UNITED STATES PATENT AND TRADEMARK OFFICE

APPLICATION NO.	FILING DATE	FIRST NAMED INVENTOR	ATTORNEY DOCKET NO.	CONFIRMATION NO.
10/602,253	06/23/2003	Salman Akram	2269-3091.5US (96-0890.04)	1942
24247	7590	09/22/2004	EXAMINER ANDUJAR, LEONARDO	
TRASK BRITT P.O. BOX 2550 SALT LAKE CITY, UT 84110			ART UNIT 2826	PAPER NUMBER

Office Action Summary	Application No. 10/602,253	Applicant(s) AKRAM, SALMAN	
	Examiner Leonardo Andújar	Art Unit 2826

DETAILED ACTION

FIG. 5

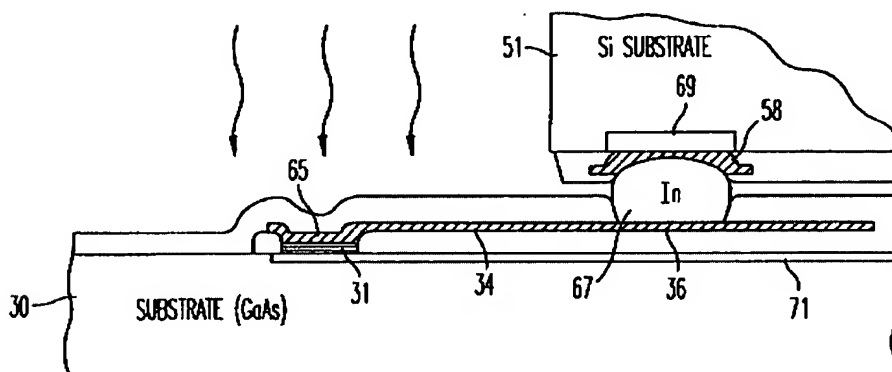
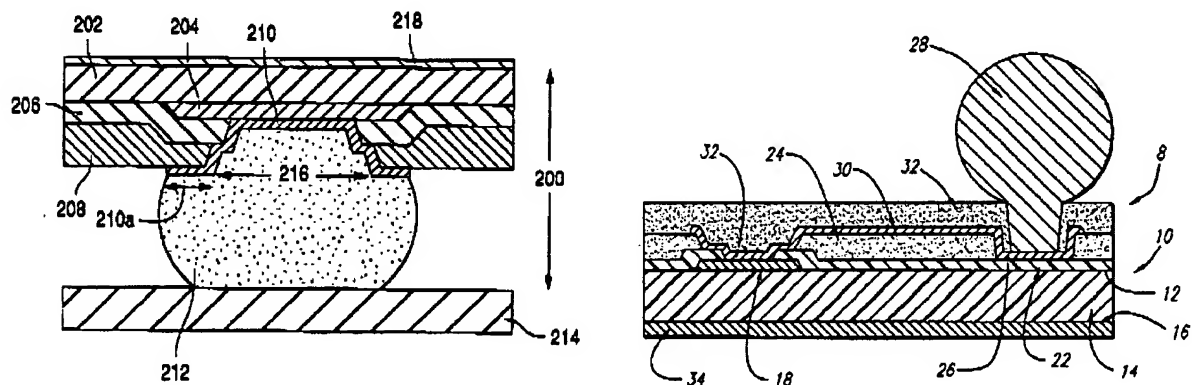
6. Regarding claim 1, Duboz (e.g. fig. 5) shows most aspects of the instant invention including a semiconductor substrate 51; a passivation layer (not labeled) and a metal connection 58 formed in the passivation layer which has been sized and configured to temporarily receive a substantially spherical interconnection element 67 attached to a semiconductor device 30. Duboz, also, shows an external electrode 36 overlapping the electrodes 69.

7. Duboz does not show that the metal connection is a metal lined via formed in the passivation layer or a conductive trace overlapping a dielectric layer. Nevertheless, Schaefer shows a metal lined via 210 in a passivation layer 206/208 whereas Elenius (e.g. fig. 2) shows a conductive trace 30 on a dielectric layer 22 and a passivation layer 24 over the conductive trace. The metal lined vias according to Schafer's invention
